**RE: APPLICATION TO CHANGE PDA DEVELOPMENT APPROVAL
PDA DEVELOPMENT PERMIT FOR A RECONFIGURING A LOT (1 LOT INTO 513 LOTS, NEW ROADS,
DRAINAGE RESERVE AND PARK), OPERATIONAL WORKS (ADVERTISING DEVICES) AND
MATERIAL CHANGE OF USE – RESIDENTIAL AND OTHER USES (DISPLAY HOME, HOME BASED
BUSINESS, HOUSE, MULTIPLE RESIDENTIAL, PARK AND SALES OFFICE) IN ACCORDANCE WITH A
PLAN OF DEVELOPMENT AND CONTEXT PLAN AT 176 – 228 MOUNTAIN RIDGE ROAD, SOUTH
MACLEAN DESCRIBED AS LOT 30 ON SP309195 – ‘FLOURISH’**

The Applicant has requested that we make application, pursuant to s99 of the *Economic Development Queensland Act 2012* (ED Act), to change PDA development approval DEV2019/1013/17 (known as Flourish Estate). This amendment application seeks approval from the Minister of Economic Development Queensland (MEDQ) for changes to the following:

Figure 3: Amended Proposed Plan

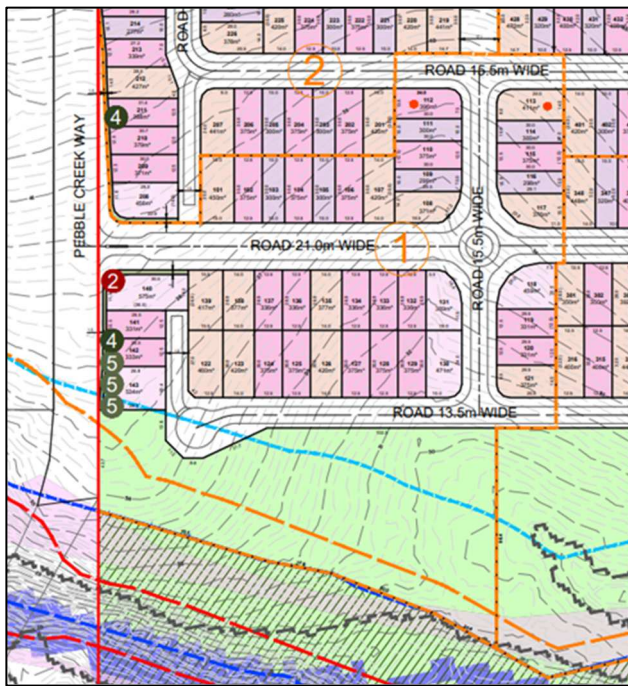
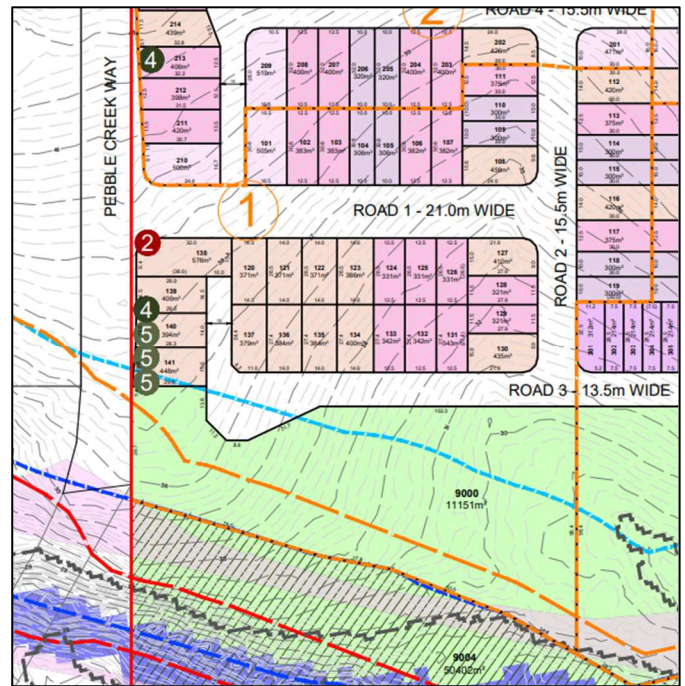
Specifically in relation to Stage 1, we note the following changes have been made when comparing the proposed Stage 1 configuration (**Figure 3**) with the current approved layout (**Figure 4**):

- A reduction in the number of Courtyard Lots. Previously, these lots were more abundant and scattered across the layout. The amended proposed plan (**Attachment B**) has fewer Courtyard Lots, and these are more selectively placed, reflecting a shift towards increased 'premium' lots types in Stage 1.
- The overall distribution and configuration of lot types have been amended;
- Inclusion of a new roundabout within Stage 1 at the termination of the neighbourhood connector entry road, providing for a more connected and convenient entry experience;
- Consequential amendments to staging;
- Introduction of a landscape buffer along Pebble Creek Way, at the frontage of Lots 140-143 to provide for an enhanced entry experience to this part of Flourish;
- Introduction of two identified Multiple Dwelling allotments.

Figure 5: Amended Proposed Plan

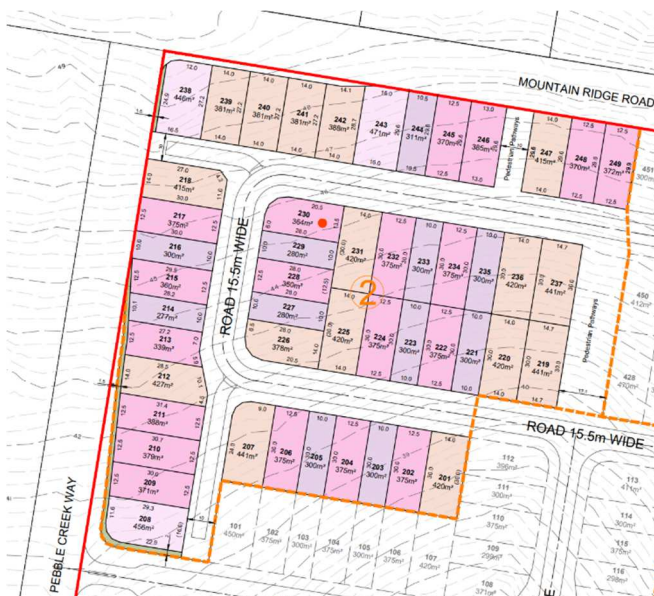
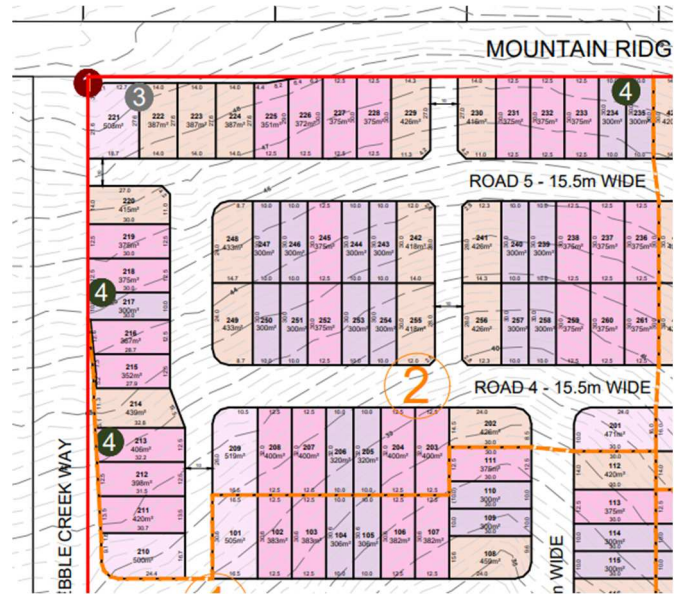
Specifically in relation to Stage 2, we note the following changes have been made when comparing the proposed Stage 2 configuration (**Figure 5**) with the current approved layout (**Figure 6**):

- The overall distribution and configuration of lot types have been amended;
- Consequential amendments to staging;
- Introduction of a landscape buffer along Pebble Creek Way, at the frontage of Lots 208-215 to provide for an enhanced entry experience to this part of Flourish;
- Relocation/ widening of pedestrian pathways in accordance with engineering advice;
- Introduction of an identified Multiple Residential allotment.

Figure 7: Amended proposed plan

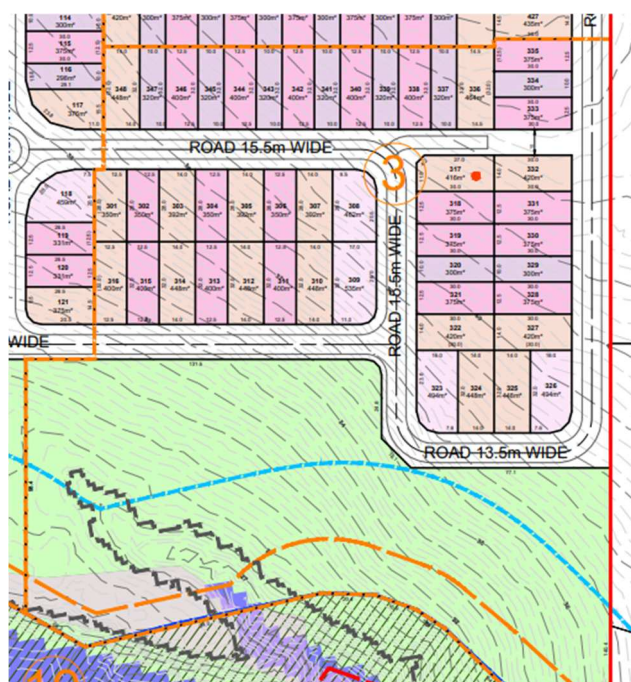
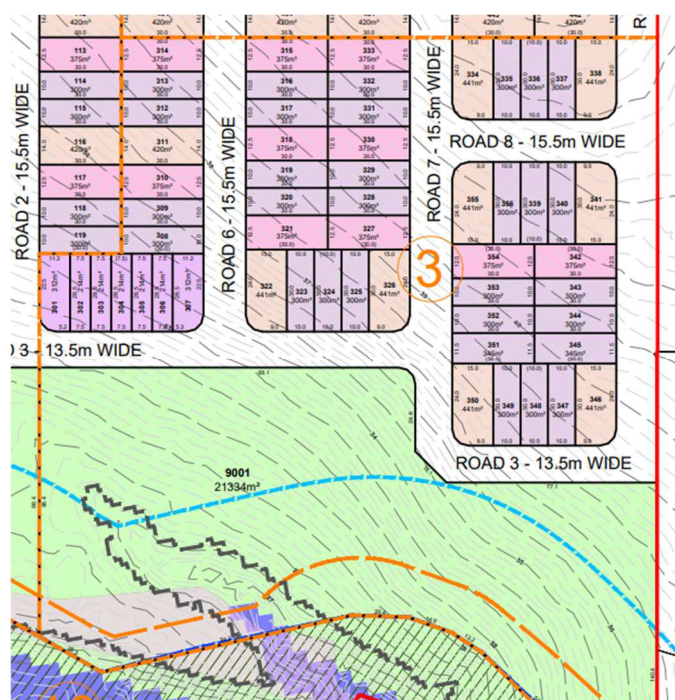
Specifically in relation to Stage 3, we note the following changes have been made when comparing the proposed Stage 3 configuration (**Figure 7**) with the current approved layout (**Figure 8**):

- Changes to the grid to incorporate more north-south oriented lots and a more logical grid pattern across Stages 3 & 4;
- Removal of 7 Terrace Lots and inclusion of one identified Multiple Residential allotment;
- The overall distribution and configuration of lot types have been amended;
- A 30m x 10m pedestrian pathway has been added to the eastern side to replicate the previously approved road corridor through this area; and
- The staging boundary line has been consequentially amended.

Figure 10: Approved plan

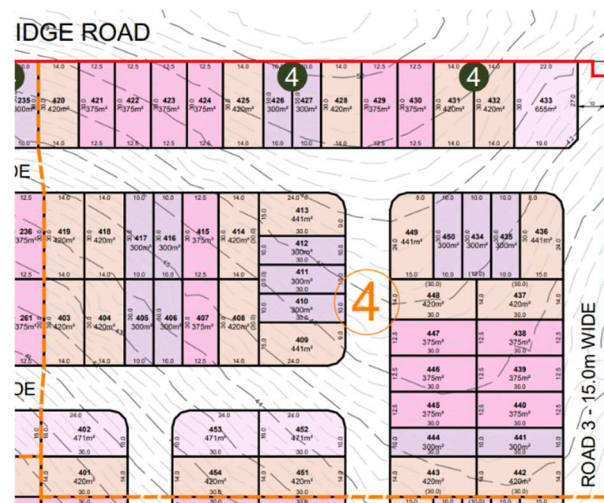
Specifically in relation to Stage 4, we note the following changes have been made when comparing the proposed Stage 4 configuration (**Figure 9**) with the current approved layout (**Figure 10**):

- Changes to the grid to incorporate more north-south oriented lots and a more logical grid pattern across Stages 3 & 4;
- Inclusion of 3 identified Multiple Residential allotments;
- The overall distribution and configuration of lot types have been amended;
